Trudeau Building Rehabilitation

Addendum #2: Historic Saranac Lake – Trudeau Building Rehabilitation
PROJECT LOCATION: Reconstruction at 118 Main Street, Saranac Lake, NY 12983
Issue Date: February 5th, 2023

Please be advised of the changes noted below to the Bidding documents and responses/answers to requests for information and questions received to date during the bidding period.

1 FIRST FLOOR REFLECTED CEILING PLAN
A1.11 SCALE: 3/16" = 1'-0"

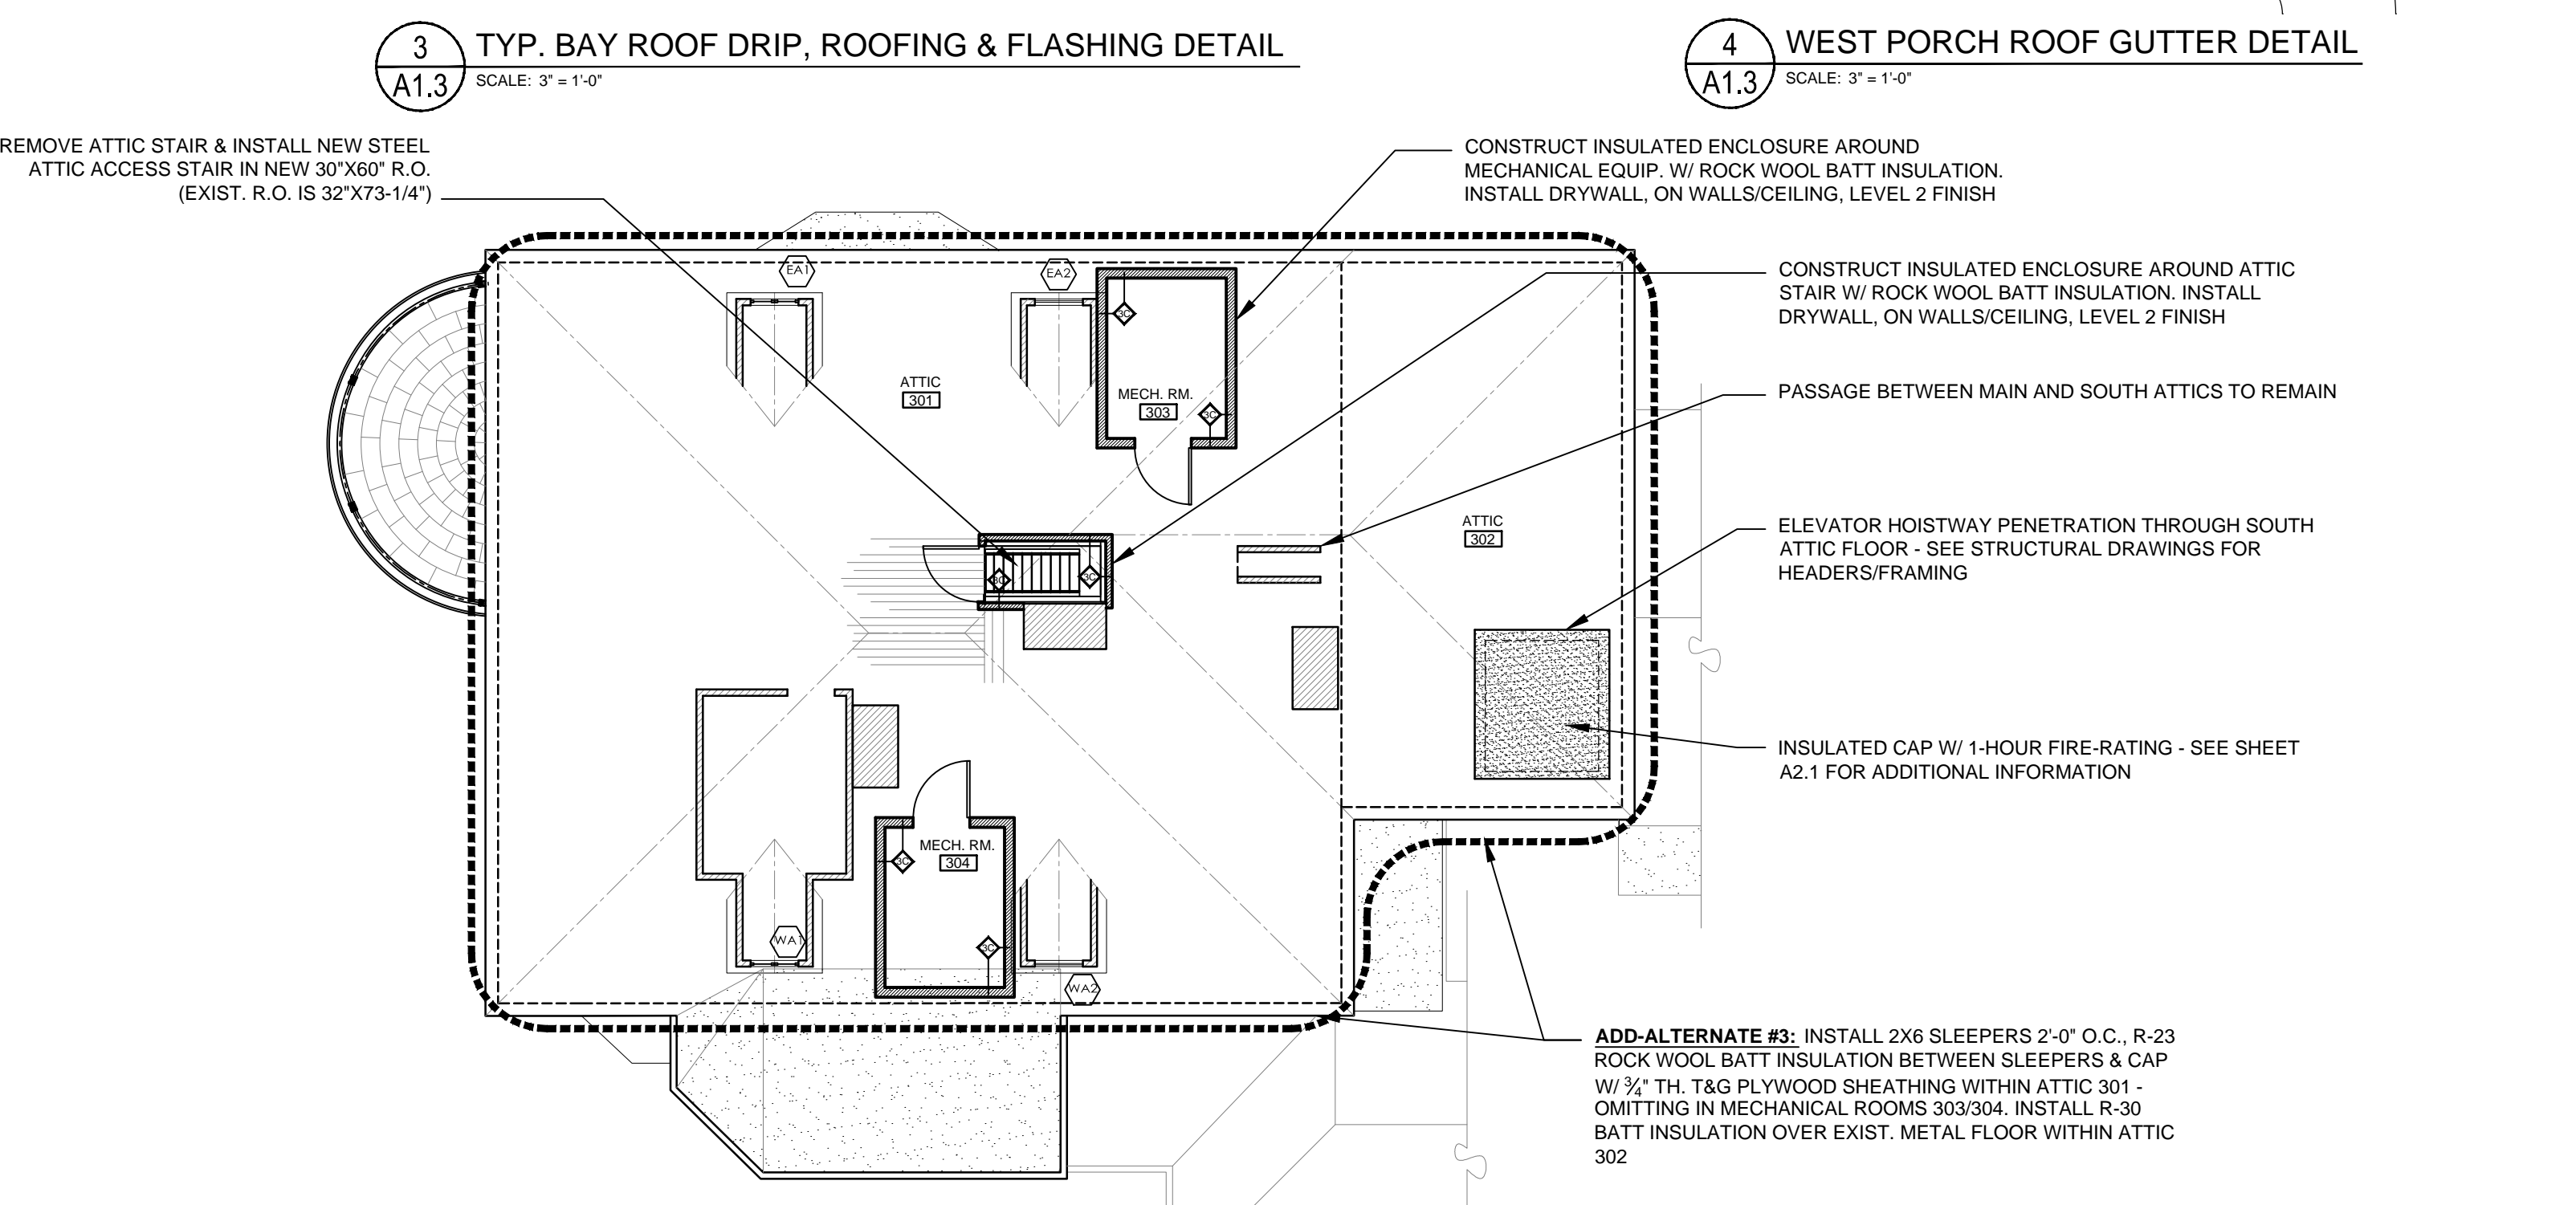
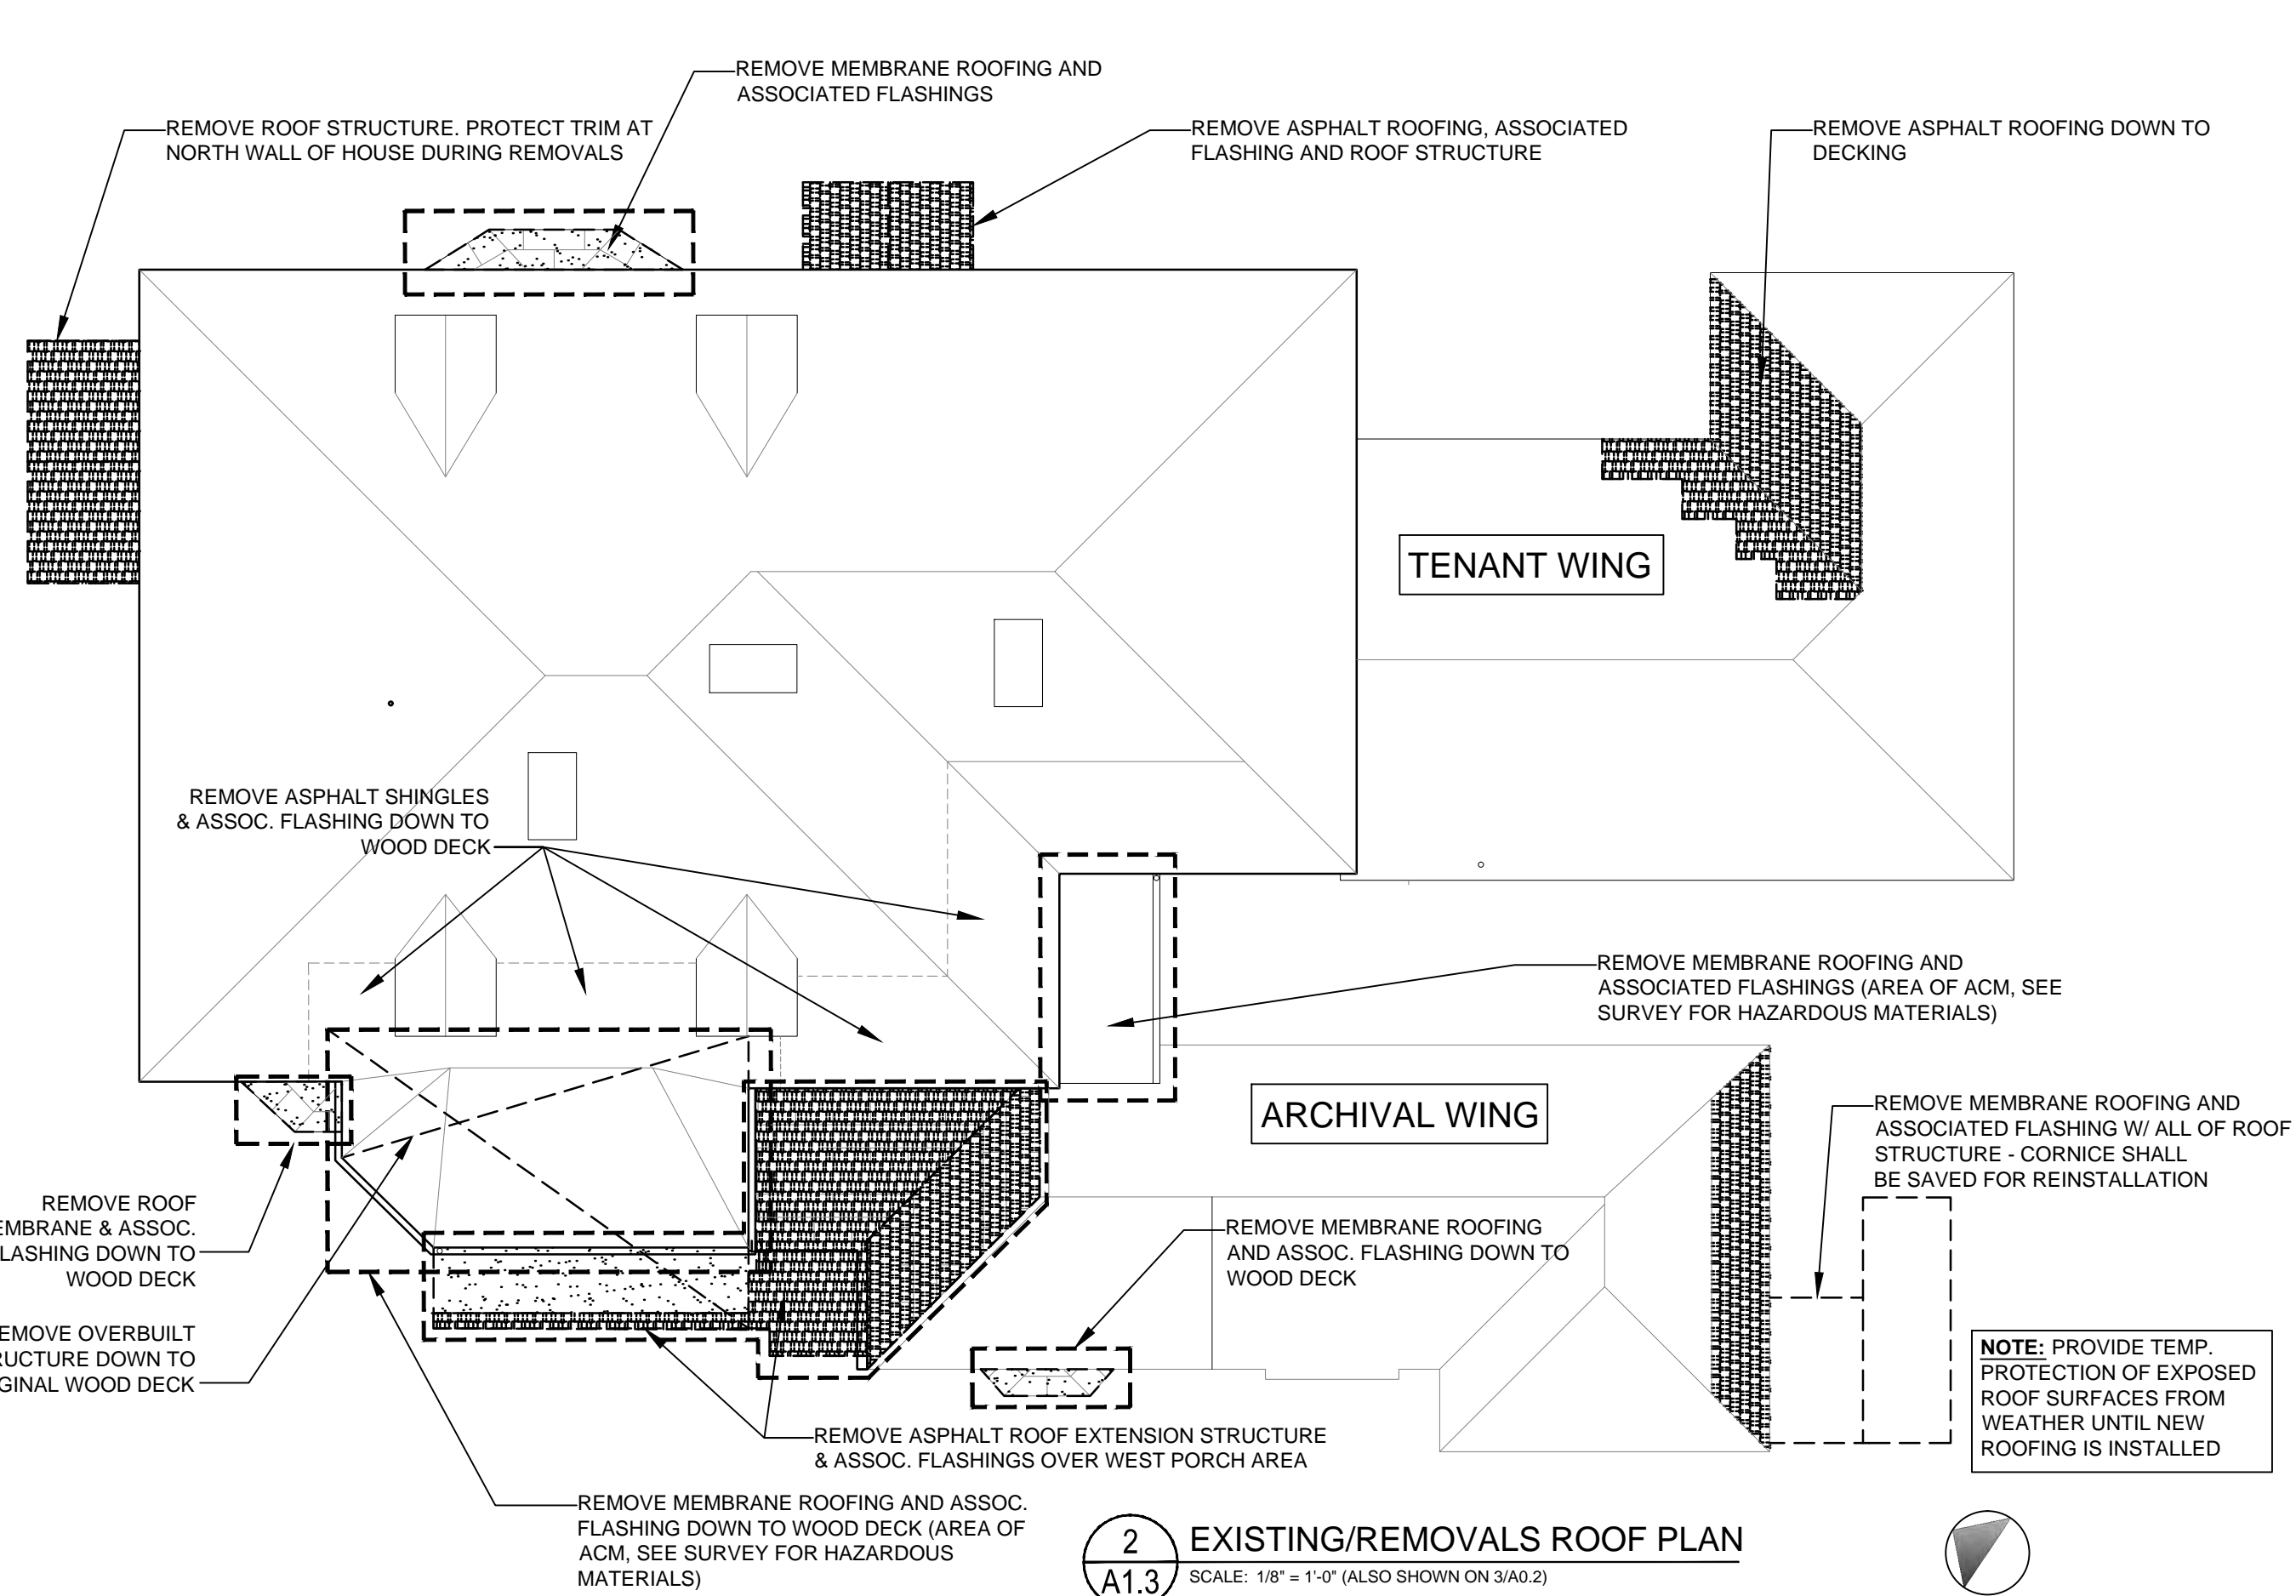
1. 1&2/A1.11: First & Second Floor Reflected Ceiling Plans
 - a. Ceiling types have been indicated with a ceiling type number within a box in selected rooms where there is new gypsum wall board anticipated to be fastened to existing plaster ceilings or exposed ceiling joists (Ceiling Type 6), the installation of suspended acoustic ceiling tile beneath existing plaster or gwb ceilings (Ceiling Type 7) or wood beaded board ceiling within porches & North Portico (Ceiling Type 8) or suspended gypsum wall board (Ceiling Type 9).

- b. Horizontal chases in Rooms 104 and 117 now have a dimension shown as well as ceiling height above finished floors. Also shown is the vertical chase in the NW corner of Office 124 that contains a new 8x8 duct connecting the energy recovery unit in the crawlspace below 124 with the horizontal chase in 117. Detail 3/A5.3 is referenced on both horizontal chases in Gallery 104 and Office 124.
